UNITED STATES
NUCLEAR REGULATORY COMMISSION
WASHINGTON, D.C. 20555-0001

FACILITY: Calvert Cliffs Nuclear Power Plant, Unit Nos. 1 and 2

SUBJECT: SUMMARY OF JUNE 12, 2013, MEETING WITH CONSTELLATION ENERGY GROUP, INC., TO CONTINUE DISCUSSIONS ON THE PROPOSED RISK-INFORMED APPROACH TO THE RESOLUTION OF GENERIC LETTER 2004-02, "POTENTIAL IMPACT OF DEBRIS BLOCKAGE ON EMERGENCY RECIRCULATION DURING DESIGN BASIS ACCIDENTS AT PRESSURIZED-WATER REACTORS" WITH A FOCUS ON REFINED CHEMICAL EFFECTS TESTING (TAC NO. MC4672 AND MC4673)

Revised Test Facility Conceptual Design

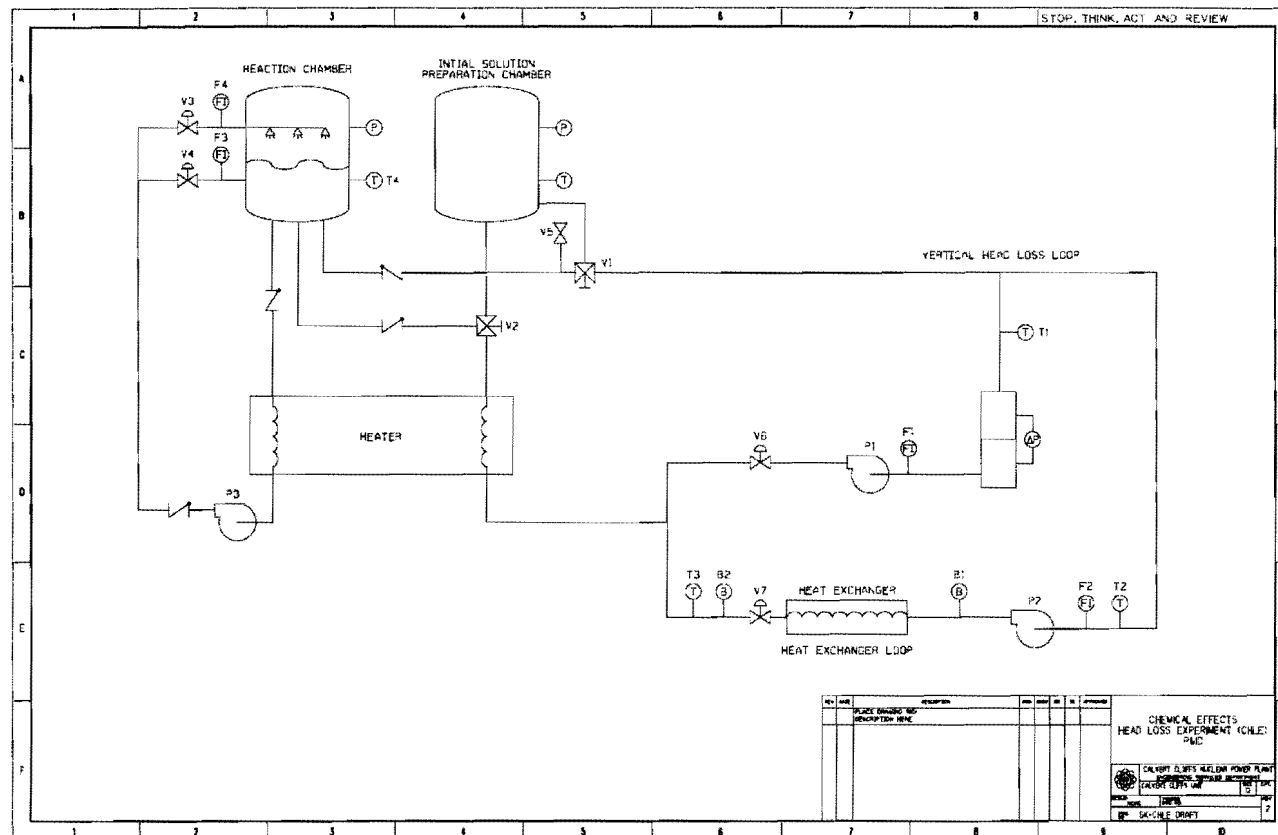
- Does Staff have Concerns with CCNPP Plans to Begin Detailed Design and Fabrication of Facility?
